**ITEM 7. DEVELOPMENT APPLICATION: STAGE 2 DEVELOPMENT APPLICATION FOR 57-75 WALKER STREET AND 44-52 MOREHEAD STREET REDFERN**

**FILE NO:** D/2007/1055

**Figure 16:** Landscape Plan

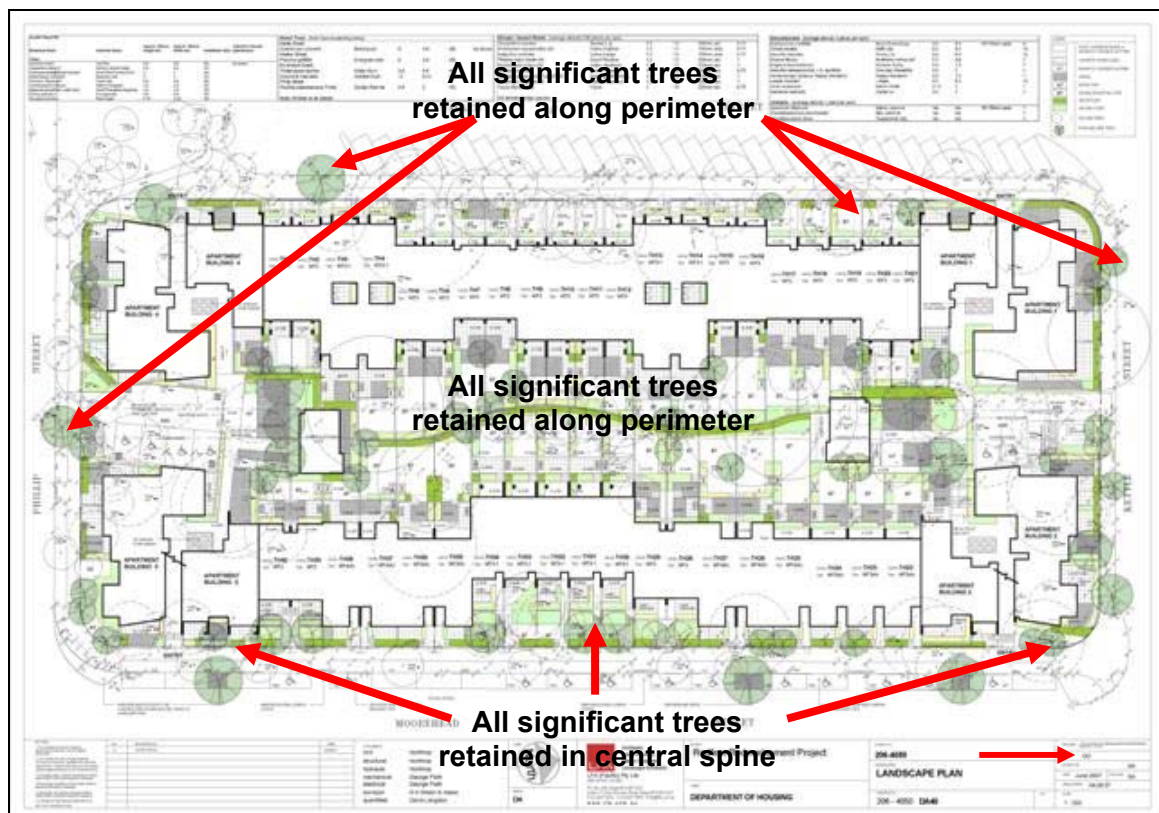
20. The proposal includes the removal of 52 native and exotic trees and retention of 52 trees. An arborist report outlining tree preservation and removal measures has been submitted to support the application.

Tree numbers 61, 80, 155, 157, 162, 166, 168, 169, 174, 177, 177b, 184, 185 and 187 are to be removed and replaced with medium sized canopy trees planted in an appropriate location. In this regard, the landscape plan is to be amended to reflect the above prior to the commencement of works on site.

**Figure 17:** South elevation to Phillip Street

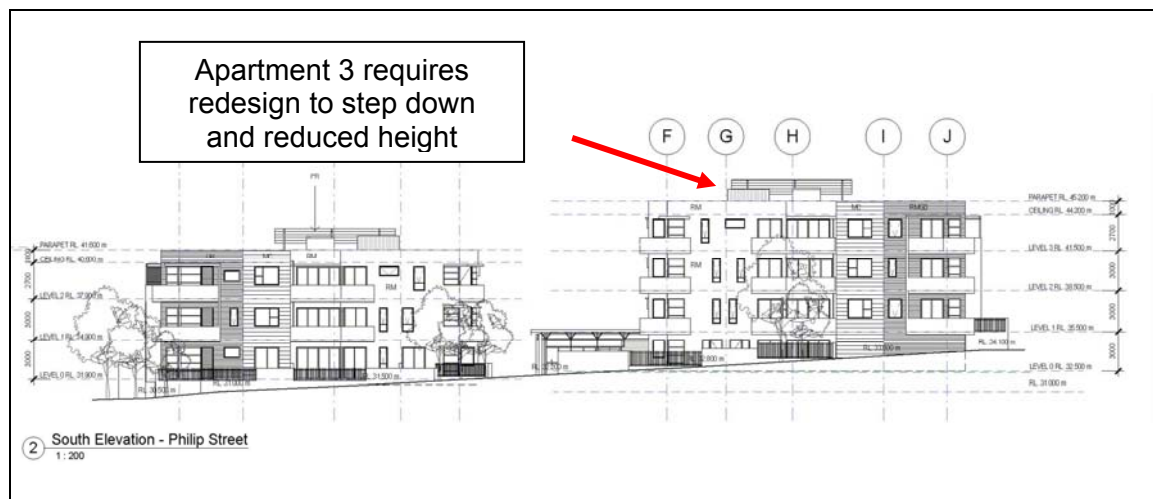
35. The application was referred to an external consultant (GMU Design) for urban design comment. In this regard, the following advice was provided:
- (a) The apartment building located at the corner of Phillip and Morehead Street should be redesigned to reduce the perceived height of the building as viewed from the opposite side of Phillip Street.

38. A condition requiring the redesign of apartment 3.13 has been included in the draft conditions of consent.

Apartment 3.13 is to be redesigned to step the apartment down in form to reduce the height at the south west corner of the site by creating a recessed wall. Amended plans are to be submitted to and approved by the Director of City Planning and Regulatory Services prior to the commencement of works on site.
